VSR-TSB-035

NHTSA Campaign Number: 22V-378

Vehicle Safety Recall - Technical Service Bulletin

Attention: Oshkosh Product Owner
Subject: Alternator and Hood Pump Cable Routing
Models Affected: Oshkosh S-Series 2.0 Front Discharge Mixer
Model Year: 2019-2022 (VIN 788727 - 814106)
Date: June 2022

Figure 1

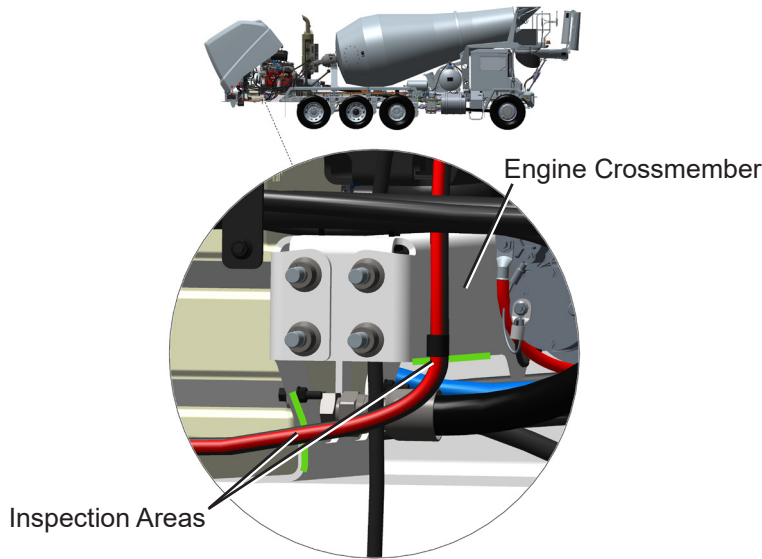
3. Inspect alternator positive and negative cables for signs of wear to cable sleeve or insulation along front side edges of rear engine crossmember. See Figure 1.
4. If either cable shows signs of sleeve or insulation wear during inspection replace cable. If there are no signs of wear continue to Step 5 for updated cable routing and cushion clip positioning.

Figure 2

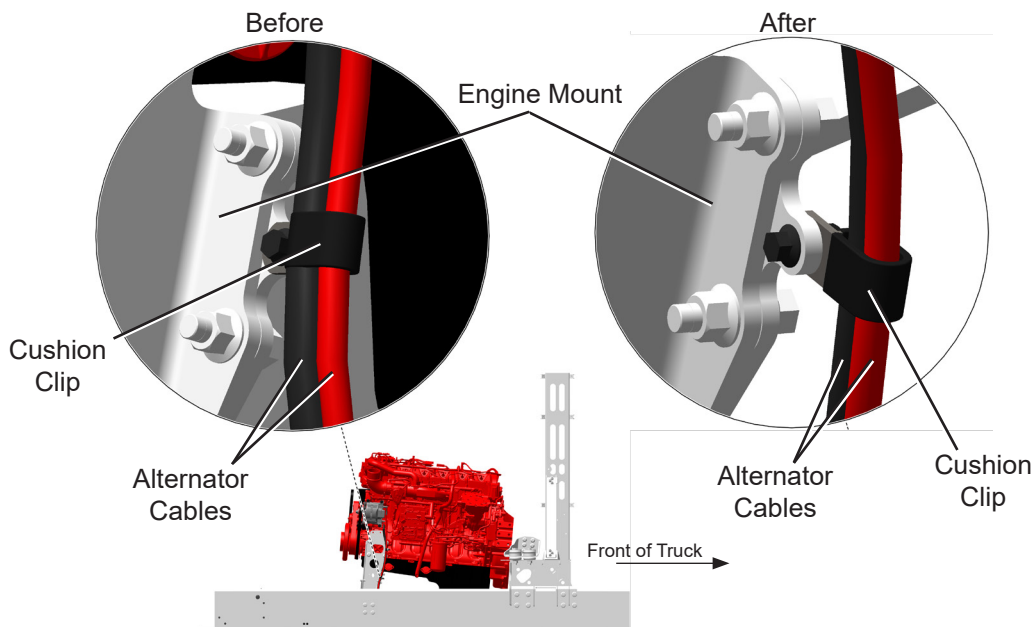
5. Locate cushion clip securing engine alternator cables to engine mount. See Figure 2.
6. Loosen and remove 0.25-20 x 1.0 inch screw and lock nut securing cushion clip to engine mount. See Figure 2.
7. Rotate cushion clip removed in Step 6 180 degrees and reinstall on front side of engine mount. See Figure 2.
8. Reinstall 0.25-20 x 1.0 inch screw and lock nut to secure cushion clip to engine mount. See Figure 2. Final tighten cushion clip mounting hardware to 9 ft. lbs.

Figure 3

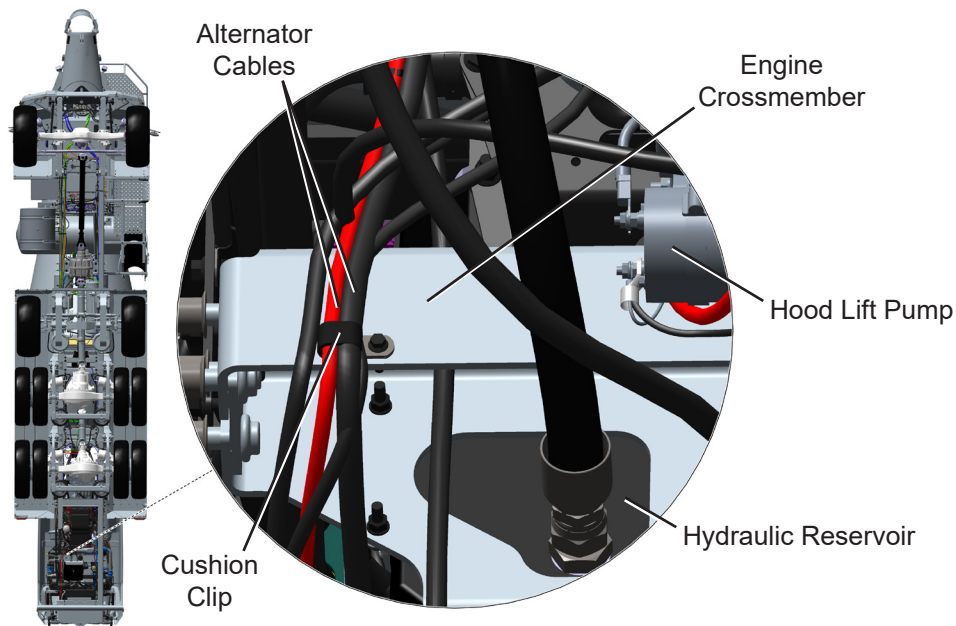
9. Locate cushion clip securing engine alternator cables to rear engine crossmember. See Figure 3.
10. Loosen and remove 0.25-20 x 1.0 inch screw and lock nut securing cushion clip to rear engine crossmember. See Figure 3.

Figure 4

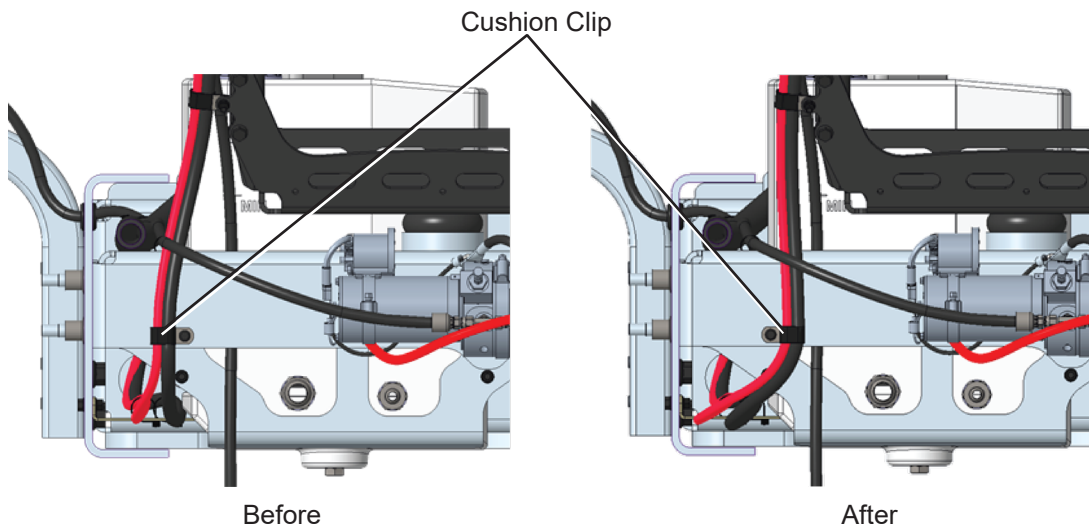
11. Rotate cushion clip removed in Step 10 180 degrees and reinstall on engine alternator cables. See Figure 4.
12. Reinstall 0.25-20 x 1.0 inch screw and lock nut to secure cushion clip to rear engine crossmember. See Figure 4. Final tighten cushion clip mounting hardware to 9 ft. lbs.

Figure 5

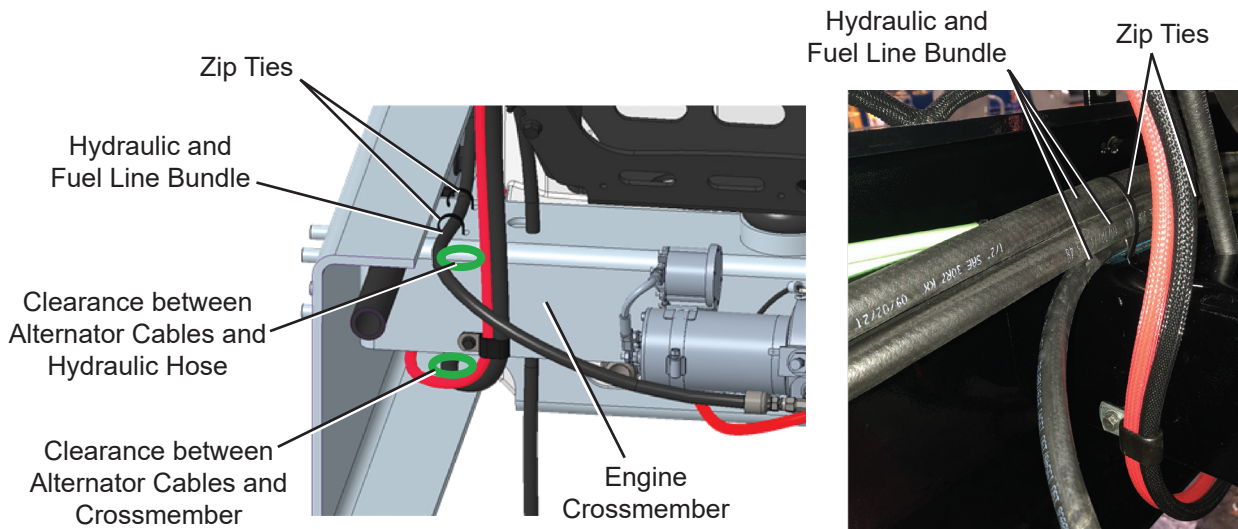
13. Make sure there is clearance between hood lift pump hydraulic line and engine alternator cables. See Figure 5. Adjust cushion clip and engine alternator cables as required to provide clearance.
14. Make sure there is clearance between bottom of engine crossmember and engine alternator cables. See Figure 5 and Figure 6. Adjust cushion clip and engine alternator cables as required to provide clearance.
15. Make sure hydraulic and fuel line bundle is securely zip tied to front engine crossmember. See Figure 5.

Figure 7

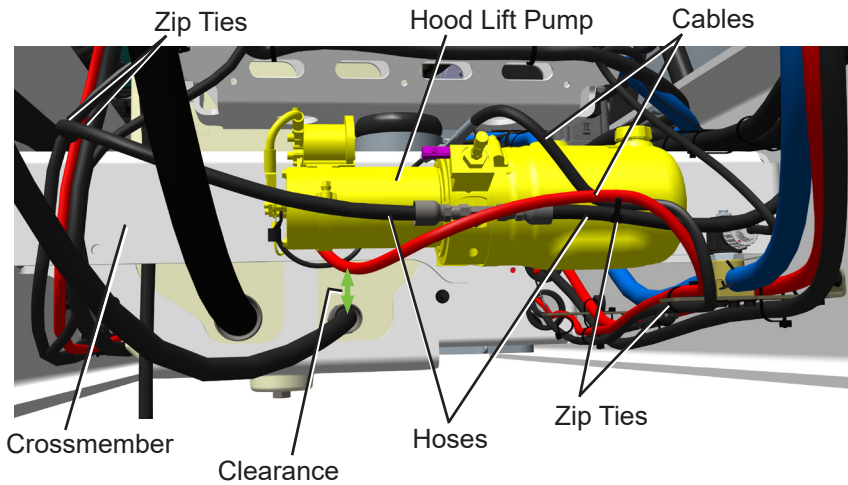
16. Inspect hood lift pump cables and hoses for signs of wear. Replace any cable(s) and hose(s) that show signs of wear. See Figure 7.
17. Make sure hood lift pump cables and hoses are routed and secured correctly. See Figure 7.
18. Make sure there is clearance between hood lift pump positive cable and hydraulic tank return hose. See Figure 7.
